UTILITY WORKSHEET

Utility Company Name	PLEASE RETURN THIS WORKSHEET BY
ANR Pipeline	November 20, 2018
Project Description – Include Project ID, Title, Limits, Highway, County	RETURN TO
Design Project ID: 6590-02-05	John Beckfield
Construction Project ID: 6590-02-75	CBS Squared, Inc.
WAUPACA - CLINTONVILLE	770 Technology Way
WCL RR BRIDGE - STH 110S	Chippewa Falls,WI 54729
STH 022, Waupaca County	jbeckfield@cbssquaredinc.com

SHEET NAME: PPSTH22 (1)

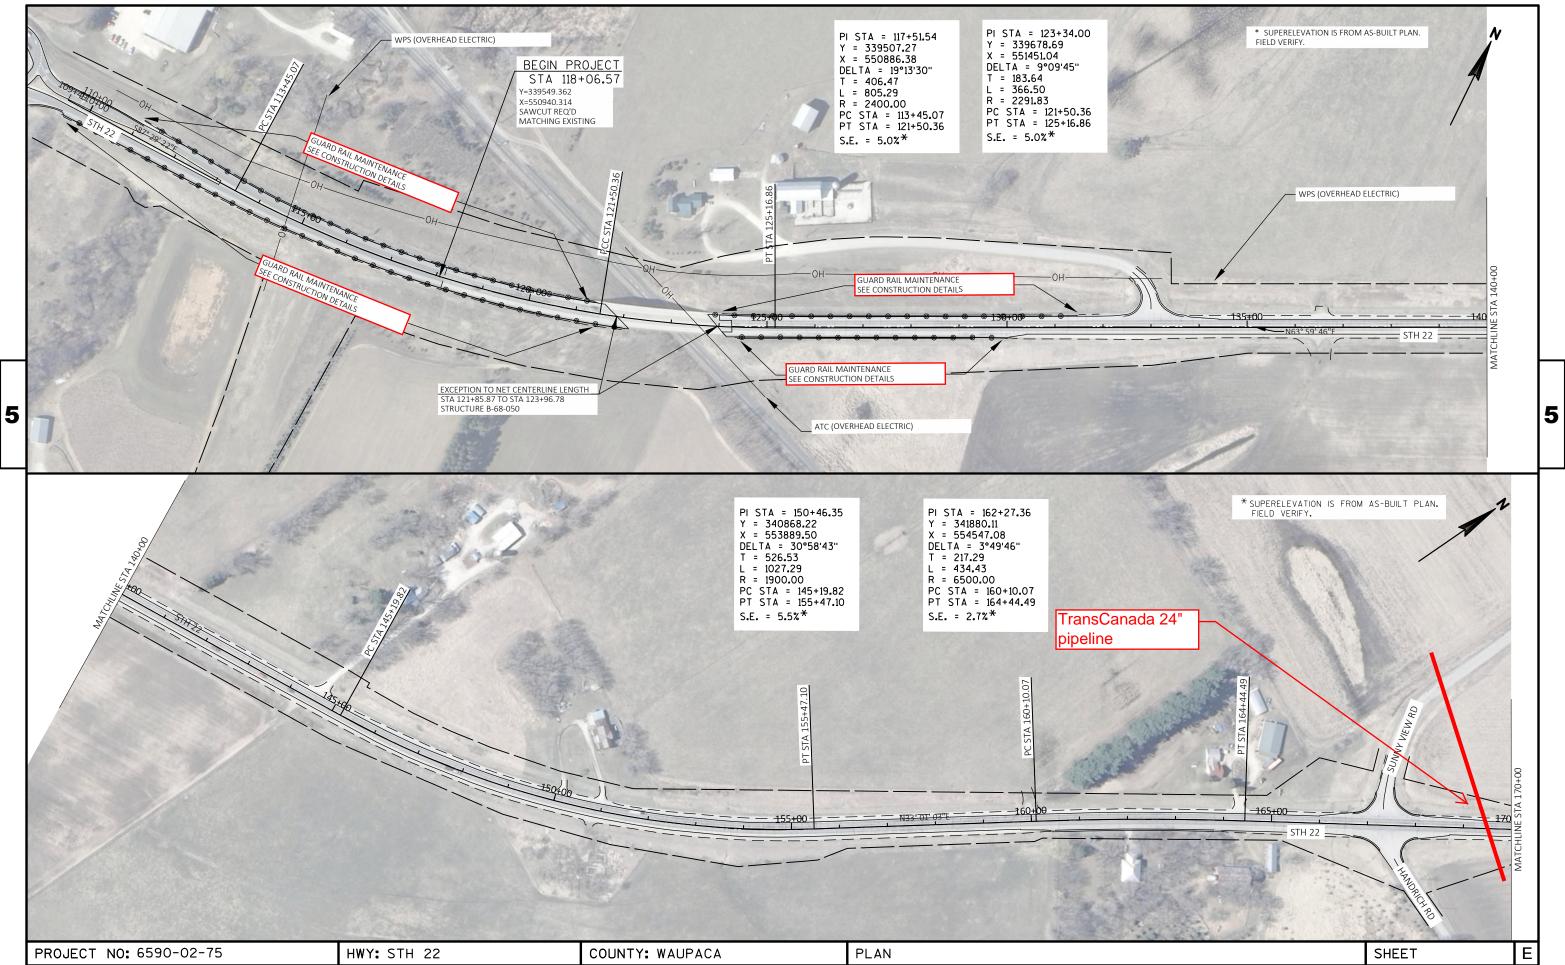
Rev #1; The plans do not show the location of the 24" pipeline crossing STH 022. See attached plan mark-up showing the pipeline crossing location.
